CHANGE NOTIFICATION

XH5B Half-Pitch Connector - Changes to Absorption pad

Shape and Dimension of Absorption Pad:

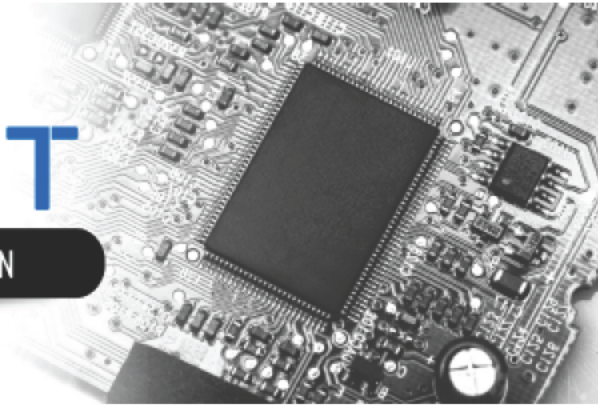
In an effort to enhance our production process, Omron will change the shape and dimensions of the absorption pad used to facilitate pick and place assembly of the XH5B Series Half-Pitch Connector. The changes are expected to take effect on or before production in July 2024. This modification notice will explain the change of the shape and dimensions of the absorption pads for the XH5B Connector. This change will not alter the technical specifications. Should you have any additional questions, however, please communicate with your local OMRON Sales Professional.

Before the change

Suction cover		
	length	width	Height B
XH5B-□□15-4N	4.46	6.4	7.1
XH5B-□□16-4N			
XH5B-□□15-5N			
XH5B-□□16-5N

Terminal width dimension specified:

No dimension specified

After the change

Suction cover		
	length	width	Height B
XH5B-□□15-4N	8.4	4.95	7.13
XH5B-□□16-4N			
XH5B-□□15-5N			
XH5B-□□16-5N

Terminal width dimension specified:

6.2
